Cider Mill Village

Concept Plan

Eastern Connecticut Environmental Review Team Report

Report #620

PROJECT NO.	17-000	DATE	11/14/17	SCALE	AS SHOWN	BY	...	CHECKED BY	...	DATE	...	<p>PROPOSED SITE PLAN</p>	<p>L2.1</p>
PROJECT NO.	17-000																	
DATE	11/14/17																	
SCALE	AS SHOWN																	
BY	...																	
CHECKED BY	...																	
DATE	...

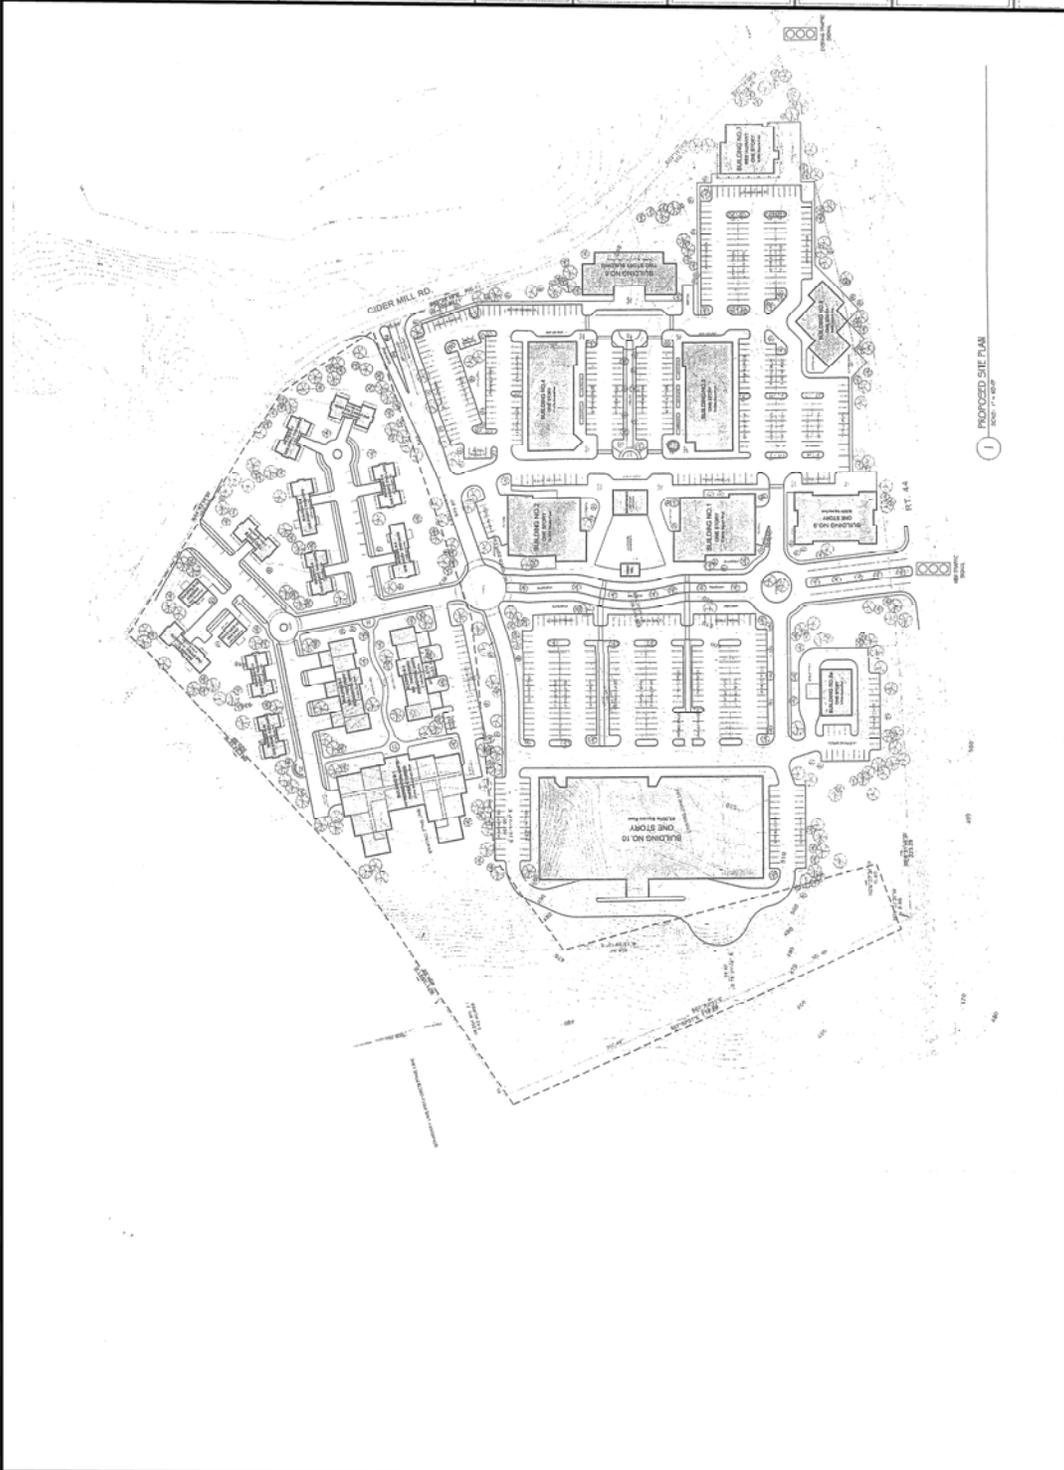
As no official project has been proposed to the Town of Bolton, the Proposed Site Plan L2.1 received on May 22nd at the ERT meeting will be used to provide comments regarding the use of Low Impact Development techniques on this site to minimize stormwater runoff impacts.

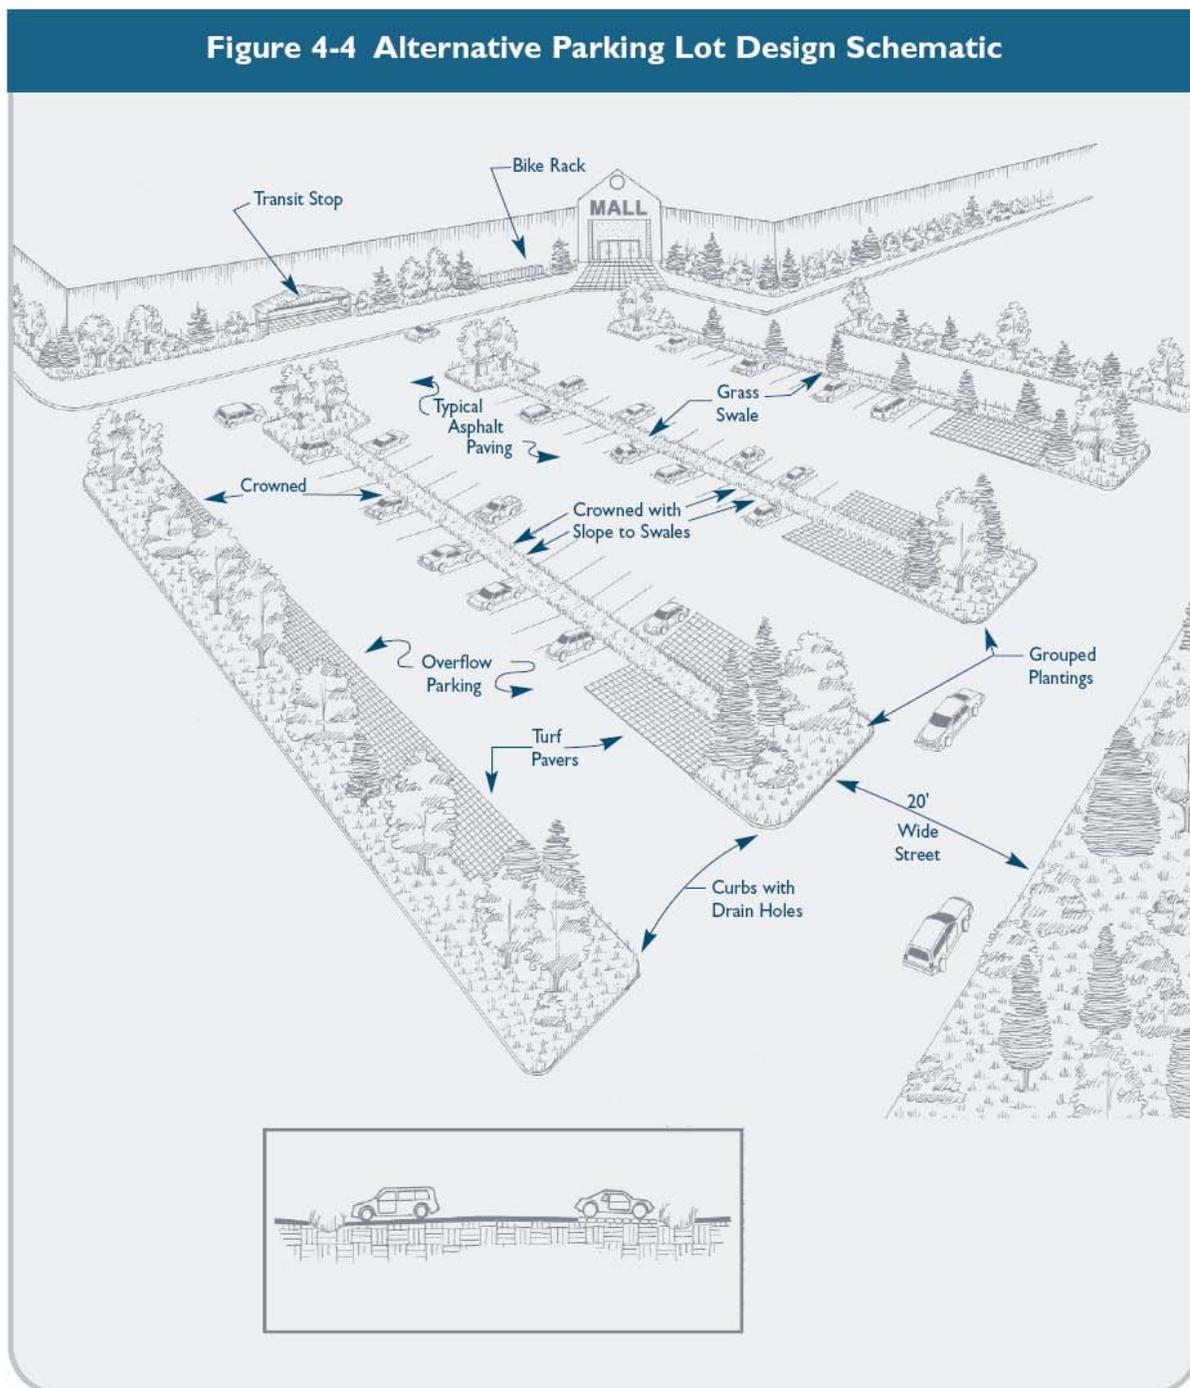
According to the Site Plan, buildings 1, 2, 6, 7, 8, and 9 currently show areas where rain gardens could be incorporated into the landscaping design to capture roof runoff. Rain gardens in close proximity to the building can effectively disconnect downspouts from

adjacent impervious areas. The remaining buildings, particularly building 10 do not appear to have adequate areas reserved to allow for close proximity infiltration. This large anchor store will have a roof area approximately the size of a football field. A greenroof could be incorporated into the design of the building in order to intercept rainfall and thereby limit the amount of runoff to downspouts. There are a number of greenroof projects throughout the state and some local companies are beginning to specialize in greenroof installations. Additionally, and ideally, the roof drains should be directed to rain gardens or bio-retention areas to further decrease the amount of runoff.

Runoff from the parking areas must also be considered in addition to loading zone “hot spots” which can have higher pollutant levels than the surrounding pavement. Several options can be considered to address this including bio-retention, swales and tree box filters. Instead of using traditional road curbing which is designed to collect and direct stormwater runoff, road sands and pollutants to the storm drainage collection system, it would be less expensive and more prudent to use sheet flow and vegetated drainage swales to promote groundwater infiltration; thereby replenishing groundwater supplies and reducing maintenance, such as seasonal sweeping, catch basin cleaning, and maintenance of the infiltration basin.

The proposed site plan shows several acres of paved surfaces. Increasing impervious surfaces leads to more runoff and transport of more pollutants. Paved areas such as roads and parking lots should be reduced as much as possible. Parking areas generate rapid stormwater runoff and carry along with it all of the pollutants from automobiles. Multiple options exist to combat the impacts of runoff from the proposed parking areas. There are several types of permeable pavement, including porous asphalt and concrete, concrete block pavers and structural grass that allow for infiltration of precipitation and can reduce or eliminate the need for structural stormwater controls. These products provide an excellent means of infiltration and can provide removal of several pollutants, including suspended solids, metals, phosphorus and petroleum hydrocarbons (University of New Hampshire Stormwater Center). Permeable pavement could also be used within the parking areas only while the travel lanes are paved with the traditional asphalt system. In a porous pavement system, roof drains from adjacent buildings can be linked to the underlying gravel layers of the system, which would allow that runoff to infiltrate into the ground. A curb less design for the parking lots in conjunction with bio-retention areas and grassed swales can intercept and filter runoff and associated pollutants. A curbed design with the addition of curb cuts to allow runoff to filter into the swales and bio-retention areas is another option that could be considered.
